### 3.4 Instrumentation and Control

STD DEP T1 3.4-1 (Figure 3.4a, Figure 3.4b, Figure 3.4c)

Figure 3.4a Safety System Logic and Control (SSLC) ~~Control~~ Interface Diagram

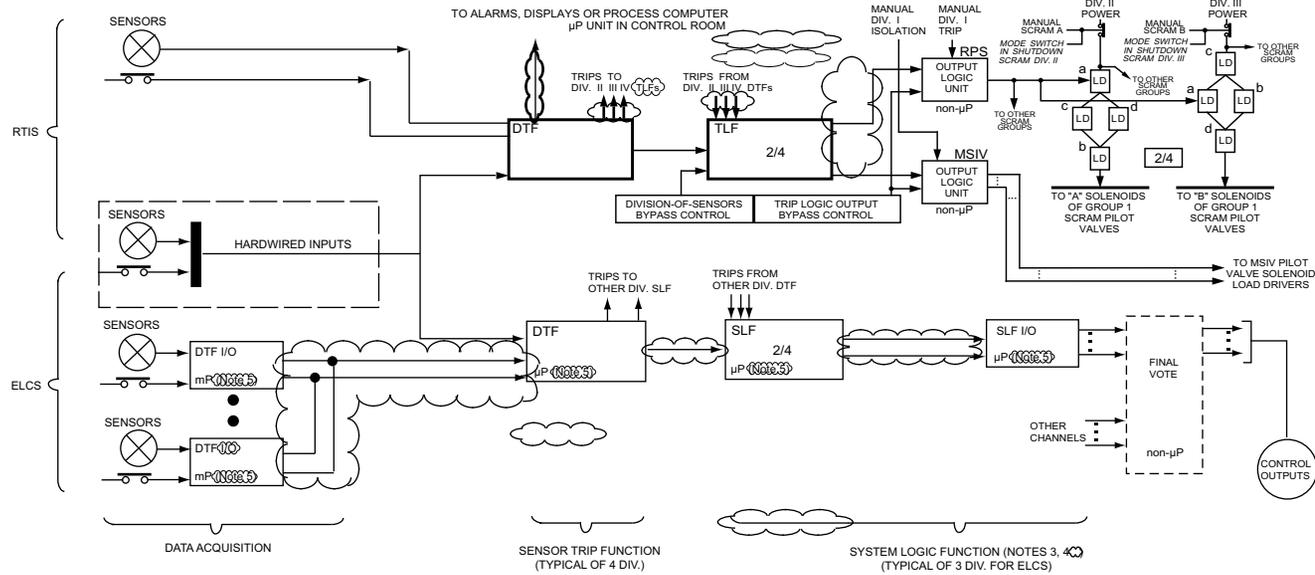
safety-related portions of the Neutron Monitoring System (NMS), the Containment Atmospheric Monitoring System (CAMS) and the radiation monitoring systems. The relationship between SSLC and systems for plant protection is shown in Figure 3.4a.

**Figure 3.4b Safety System Logic & Control Block Diagram**

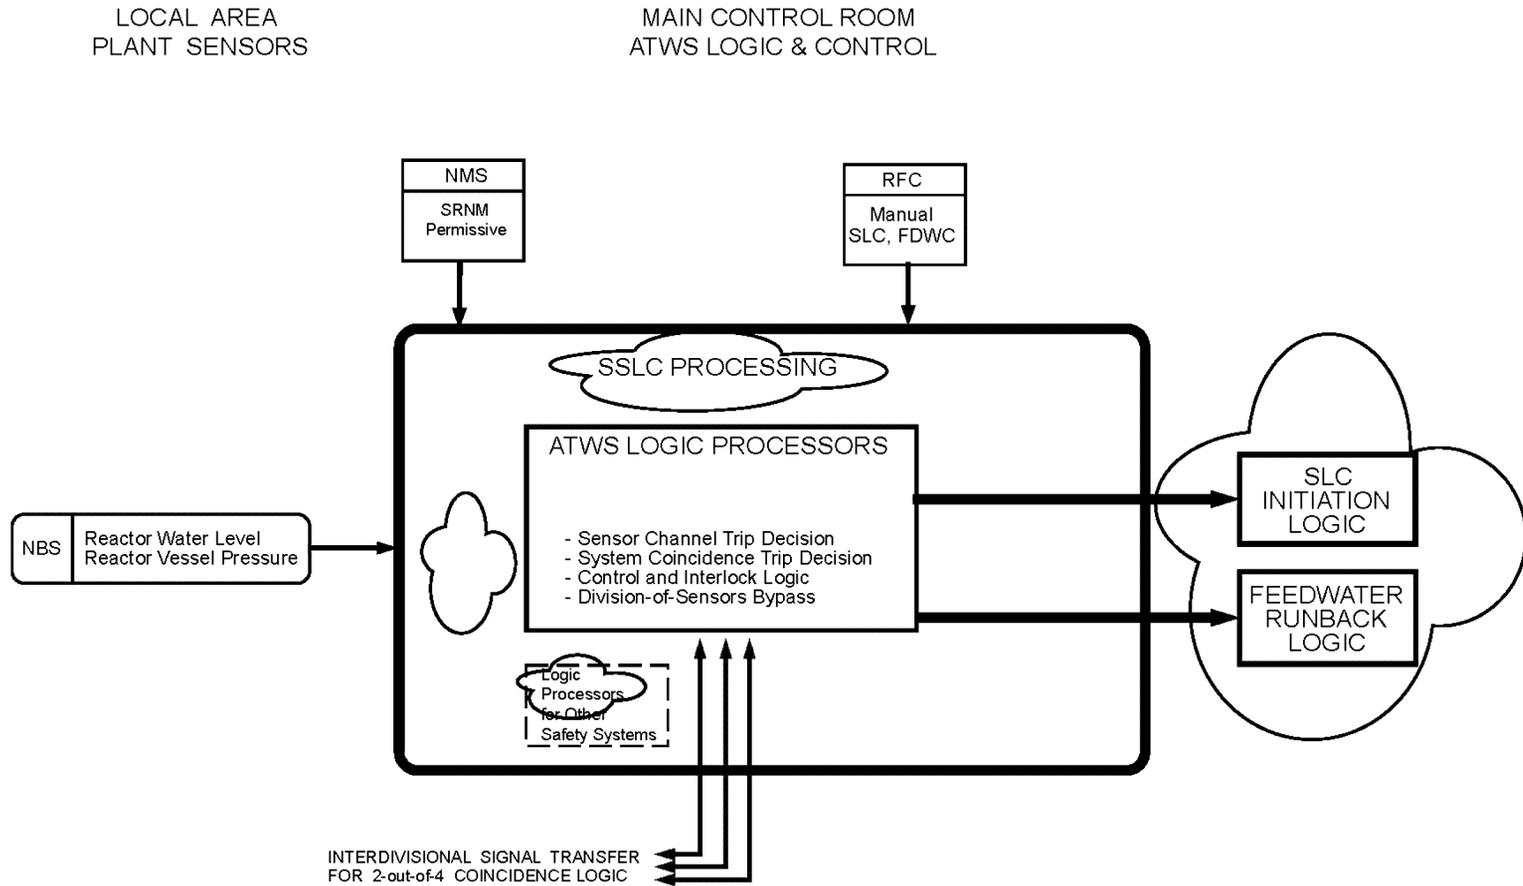
~~The basic hardware functional configuration for one division of SSLC is shown in Figure 3.4b. Each division runs independently (i.e., asynchronously) with respect to the other divisions. The following steps describe the processing sequence and associated function descriptions for incoming sensor signals and outgoing control signals. These steps are performed simultaneously and independently in each of the four divisions:~~

- ARRANGMENT SHOWN IS A SIMPLIFIED EXAMPLE FOR ONE DIVISION
- NOT ALL CONTROL SWITCH INPUTS SHOWN.  
B. INPUTS FROM NMS AND PRM NOT SHOWN.  
C. INTERDIVISIONAL COMMUNICATIONS USE FIBER OPTIC DATA LINKS.

- ALL SOLID LINE CONNECTIONS NOT EXPLICITLY IDENTIFIED CAN BE EITHER HARD WIRED OR FIBER OPTIC.
- SAFETY SYSTEM LOGIC FUNCTION (SLF) FOR ECCS FUNCTIONS IS IMPLEMENTED WITH REDUNDANT CHANNELS WITH A MINIMUM 2/2 VOTE OF THE OUTPUT SIGNALS TO PREVENT INADVERTENT COOLANT INJECTION OR DEPRESSURIZATION DUE TO SINGLE SLF ELECTRONICS FAILURE. THE OUTPUT VOTE MAY BE ACCOMPLISHED EITHER BY DIRECT VOTE OF SLF OUTPUT SIGNALS OR BY A SYSTEM VOTE WHERE BOTH VALVE AND PUMP ACTUATION IS REQUIRED TO INITIATE SYSTEM ACTION. BYPASS OF A FAILED SLF CHANNEL MAY BE PROVIDED AS LONG AS THE REMAINING OPERATIONAL CHANNELS PROVIDE A MINIMUM OF TWO SLF CHANNELS FOR ECCS FUNCTIONS.**

- SAFETY SYSTEM LOGIC FUNCTION (SLF) FOR SOME ISOLATION AND SUPPORTING ESF FUNCTIONS MAY BE IMPLEMENTED WITH REDUNDANT CHANNELS WITH A NORMAL MINIMUM 2/2 VOTE OF THE OUTPUT SIGNALS WHERE INADVERTENT ACTUATION OF THE FUNCTION MIGHT REQUIRE UNREASONABLY SHORT REPAIR TIMES TO ELIMINATE OPERATIONAL IMPACT. FOR THESE FUNCTIONS, OPERATIONAL CONTROLLED BYPASS TO ALLOW OPERATION WITH A FINAL 1/1 VOTE IS PERMITTED.**

- EACH FUNCTION MAY BE ACCOMPLISHED BY MULTIPLE PROCESSORS TO MINIMIZE THE HARDWARE AND SOFTWARE COMPLEXITY OR OPERATIONAL IMPACT OF HARDWARE FAILURES, PROVIDED THE MINIMUM REDUNDANCY OF NOTES 3 AND 4 IS MAINTAINED.
